SUBJECT: BEAVER VALLEY POWER STATION, UNIT NO. 1 - RELIEF REQUEST NOS. PRR1, PRR2, PRR3, PRR4, PRR5, PRR6, PRR7, PRR8, PRR9, PRR10, PRR11, PRR12, PRR 13, AND VRR1 REGARDING THE FOURTH 10-YEAR INSERVICE TESTING PROGRAM RELIEF REQUESTS (TAC NOS. MD5118 - MD5131)

SAFETY EVALUATION BY THE OFFICE OF NUCLEAR REACTOR REGULATION
REGARDING THE FOURTH 10-YEAR INTERVAL INSERVICE TESTING PROGRAM FOR
RELIEF REQUEST NOS. PRR1, PRR2, PRR3, PRR4, PRR5, PRR6, PRR7,
PRR8, PRR9, PRR10, PRR11, PRR12, PRR13, AND VRR1
FIRSTENERGY NUCLEAR OPERATING COMPANY
FIRSTENERGY NUCLEAR GENERATION CORP.
BEAVER VALLEY POWER STATION, UNIT NO. 1
DOCKET NO. 50-334

Figure PRR11-1: Inside Recirculation Spray Pump Test Circuit

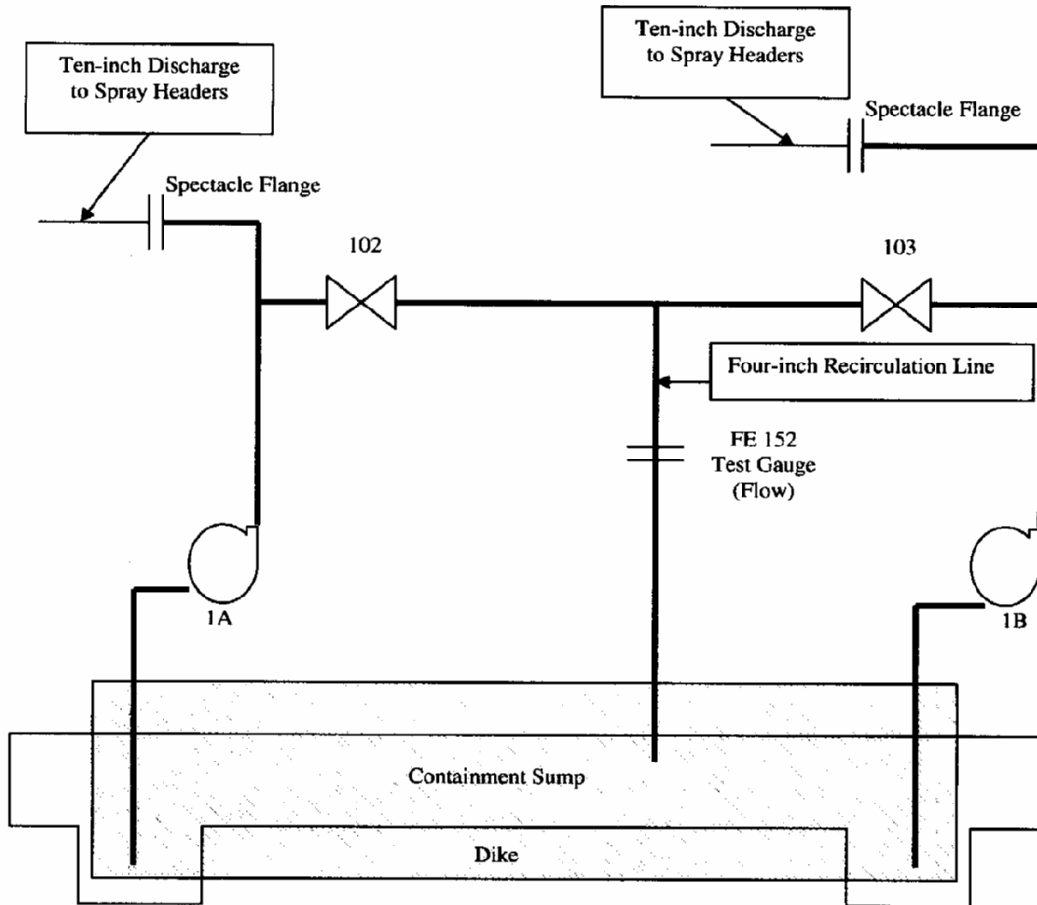
The inside recirculation spray pumps supply water from the containment sump to the spray headers to remove heat and reduce containment pressure to less than 50% of the peak calculated pressure for a LOCA within 24 hours after the postulated accident. The outside recirculation spray pumps provide containment sump water to the high head safety injection pumps to inject water into the RCS for core cooling. There are two inside recirculation pumps. The test loop for the inside recirculation pumps consists of a 10-inch discharge line feeding into a 4-inch recirculation line, which feeds back to the pump sump. The test loop for the outside recirculation pumps also consists of a 4-inch recirculation line; however, the recirculation from the outside recirculation pumps discharges to the pump casing. Pump design flow cannot be established using these test loops because of the 4-inch recirculation line size. Also, the discharge piping was not designed to be temporarily reconfigured so that pump design flow can be achieved.

replaced with plugs, temporary connections were made between the nozzle headers and containment sump. Sufficient water was then added to the containment sump so that a recirculation spray pump could recirculate water through its respective spray header. The startup test also served to completely flush the system to remove any particulate matter, which could potentially plug the spray nozzles at a future time. Upon completion of the test, water was drained from each recirculation cooler, pump, header and sump. The temporary connections between the head and sumps were removed and the spray nozzles were reinstalled.

The licensee stated, "Re-establishing this full flow test loop for the purpose of periodic design flow rate testing would require a similar modification every two years." The licensee also states that the spray headers are inaccessible without a significant amount of scaffolding. Even if the nozzles were accessible, plugging 780 spray nozzles, installing temporary piping, running the full-flow test, and returning the system to its original operable configuration would cause hardship to the licensee. Replacement of the 4-inch recirculation test line with a line of sufficient size to accommodate design flow rate testing would also cause hardship.

Figure PRR11-7

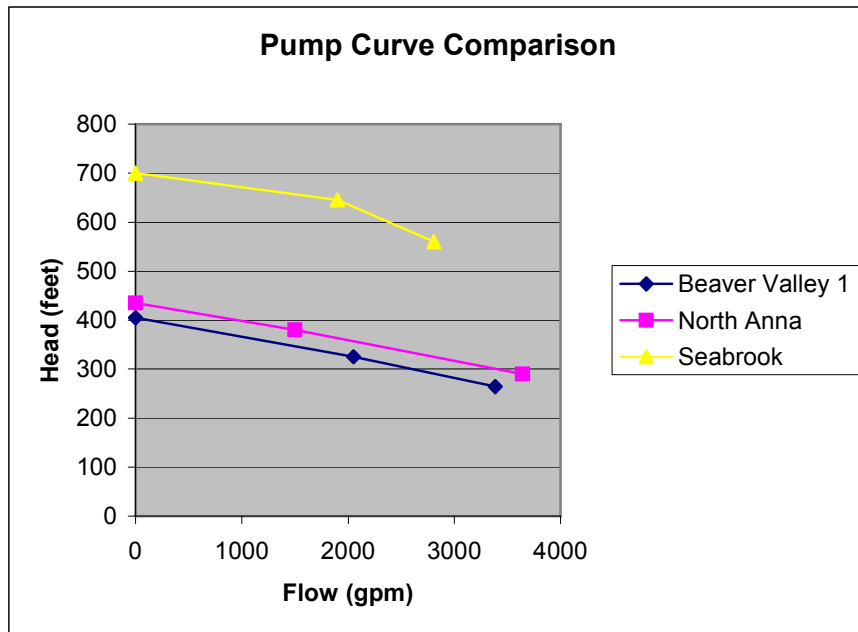
Similar relief requests were granted for the North Anna Station recirculation spray pumps (Reference 3.9.6.1) and the Seabrook Station containment spray pumps (Reference 3.9.6.2). The typical pump shutoff, test and design/accident head-flow data for North Anna Station, Seabrook Station and BVPS-1 are summarized in the table on Figure PRR11-7. Based on these head-flow data, the typical pump head-flow curves for the three plants were plotted for

comparison purposes. As can be seen from the figure, the curves for the three plants have similar shape and are well sloped (The developed head at the test flow rate for BVPS-1 is 20% below the pump shut off head). Therefore, testing at the reference flows for BVPS-1 will detect pump degradation because pump curve is well sloped at the point of testing.

Figure PRR12-1: Quench Spray Pumps Test Circuit

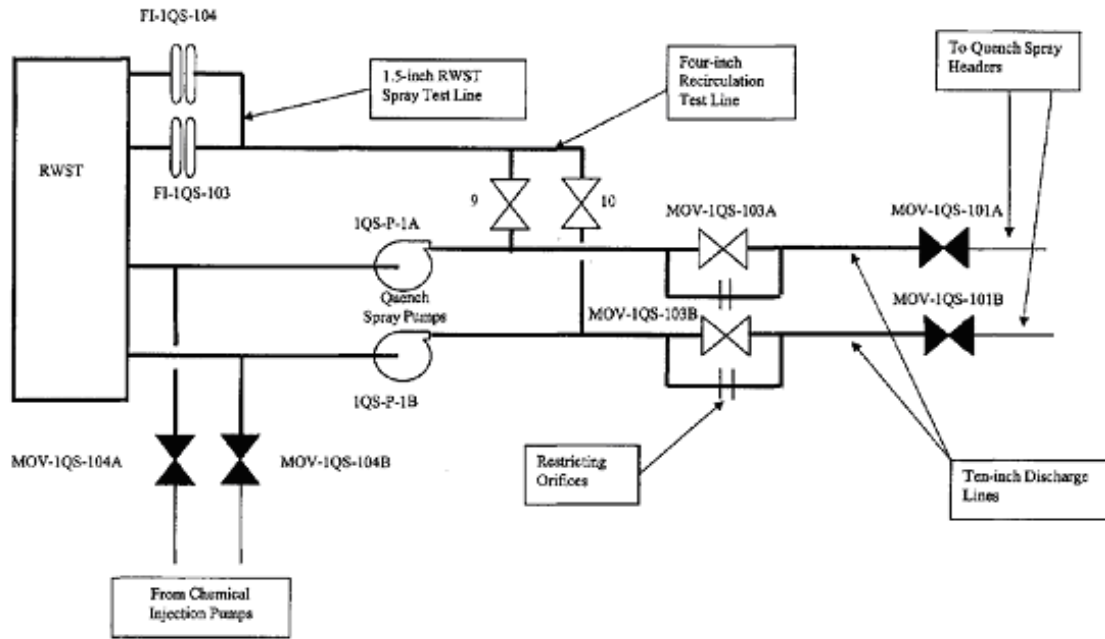
The test circuits identified in [Figure PRR12-1] will be used to satisfy testing requirements.

The quench spray pumps supply water from the RWST and spray the containment through spray nozzles. The quench spray system is designed to remove energy and heat discharged to the containment following a LOCA or main steam line break to prevent the containment pressure from exceeding design pressure and to reduce and maintain containment temperature and pressure to within acceptable limits. The system is provided with two 100% capacity redundant trains, each having a design discharge capacity of 2500 gpm. The piping configuration for the quench spray pumps consists of the pumps receiving suction from the RWST and discharging to the containment through 10-inch lines supplying the quench spray headers (see Figure PRR12-1). The pumps discharge piping is provided with 4-inch recirculation test lines. Pump design flow cannot be established using these test loops because of the 4-inch recirculation line size. Also, the discharge piping was not designed to be temporarily reconfigured so that pump accident flow can be achieved.

Re-establishing this full flow test loop for the purpose of periodic design flow rate testing would require a similar modification every 2 years. The licensee also states that the spray headers are inaccessible without a significant amount of scaffolding. Even if the nozzles were accessible, plugging spray nozzles, installing temporary piping, running the full-flow test, and returning the system to its original operable configuration would cause hardship to the licensee. Replacement of the 4-inch recirculation test line with a line of sufficient size to accommodate design flow rate testing would also cause hardship.

Figure PRR12-4

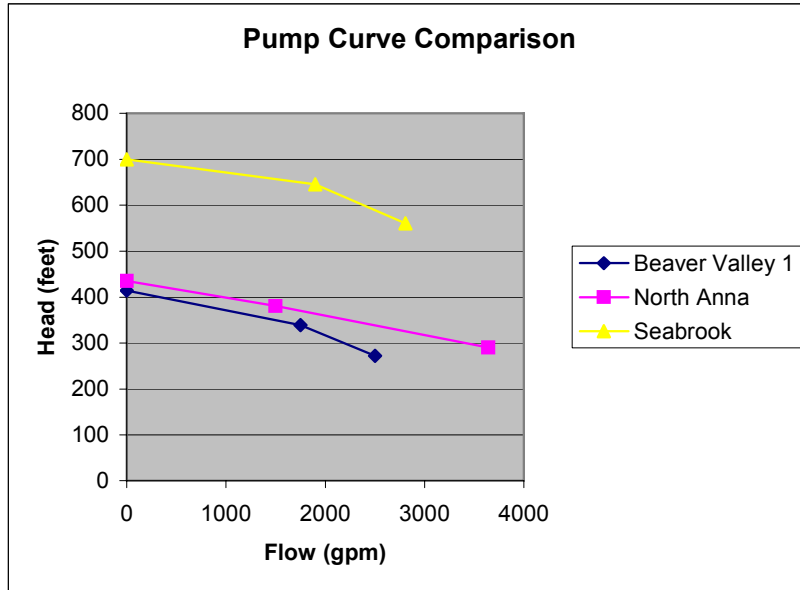
Similar relief requests were granted for the North Anna Station recirculation spray pumps (Reference 3.10.6.1) and the Seabrook Station containment spray pumps (Reference 3.10.6.2). The typical pump shutoff, test and design/accident head-flow data for North Anna Station, Seabrook Station, and BVPS-1 are summarized in the table on Figure PRR12-4. Based on these head-flow data, the typical pump head-flow curves for the three plants were plotted for comparison purpose. As seen from the figure, the curves for the three plants have similar shape and are well sloped (The TDH at the test flow rate for BVPS-1 is 18% lower than the pump shut off head). Therefore, testing at the reference flows for BVPS-1 will detect pump degradation because the pump curve is well sloped at the point of testing.
